Annex X**Test Specifications for Automated Lane Keeping Systems (ALKS)****1. General**

5.5.1. Cut-In Tests

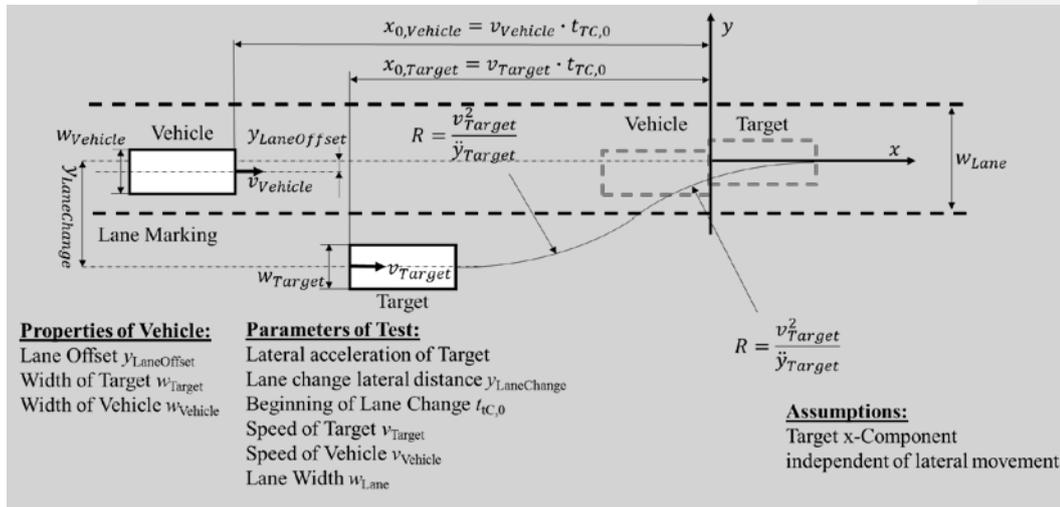
Kommentiert [N16]: This scenario is covered by the traffic disturbance scenario discussed in the VMADSG1a so seems not necessary.

5.5.2. Cut-Out Tests

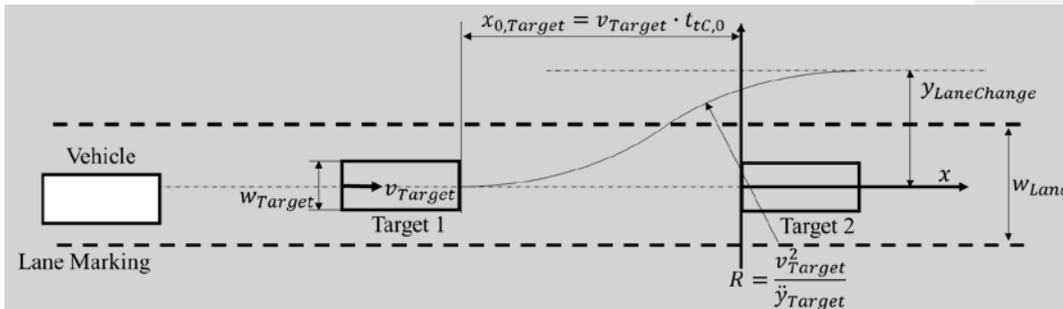
Kommentiert [N17]: This scenario is covered by the traffic disturbance scenario discussed in the VMADSG1a so seems not necessary in this Annex. Necessity of this requirement should be discussed in the SG1a.
